**WOKINGHAM
BOROUGH COUNCIL**

Full Planning Approval Consultation

Application Number: 260736

Proposal: Full application for the proposed change of use of land for the stationing of 1 no. static caravan for occupation by Gypsies / Travellers with associated access.

Figure 3.4 Priority junction visibility splays

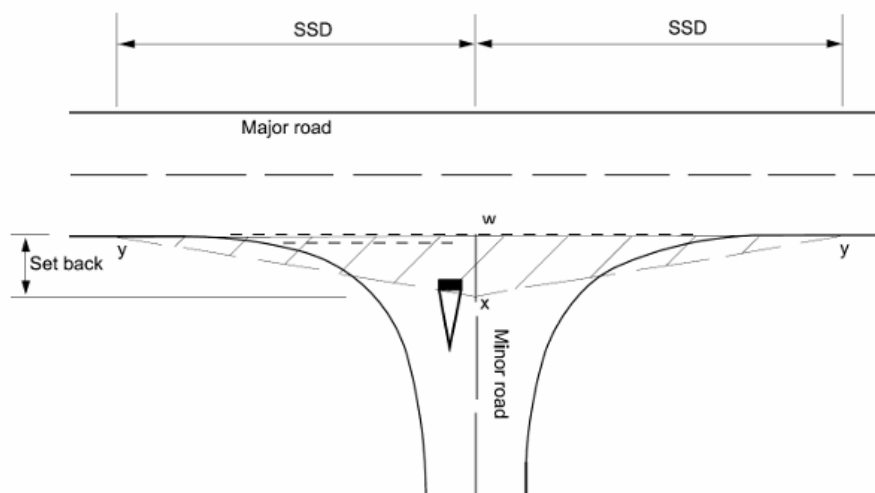
The visibility splays of 2.4m x 120m (for a 40mph road in line with DMRB) have been shown in Drawing 2509(p)132a. This section of the A327 is subject to a 50mph speed restriction therefore 2.4m x 160m visibility splays are to be shown on a revised plan. Alternatively, this can be assessed based on the speed limits of the 85-percentile speed provided by the applicant submitting full speed survey results for the road where the access is located. This is to set out the Annual Average Daily Traffic (AADT) flows.

The guidance given in DMRB CD 123 'Geometric design of at-grade priority and signal-controlled junctions' should be followed. Visibility should be measure from 2.4m set back from the major road edge of carriageway, and the splay should be taken from the set back to the nearside edge of the carriageway at the corresponding SSD for the speed of the major road:

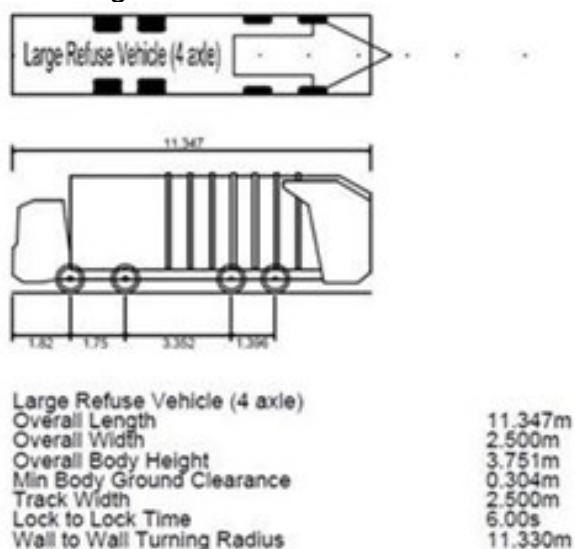
Parking is to be provided in line with WBC Parking Standards, and the minimum dimensions of each parking space is 2.5m x 5m. Drawing 2509(p)135a shows the proposed floor plans of the static caravan which is to have three habitable rooms.

For a proposed dwelling of this scale in a 'village' location, two parking spaces are required. The proposed plans show 2 parking spaces of suitable dimensions, which is welcomed. This is an acceptable parking provision in line with WBC's Parking Standards.
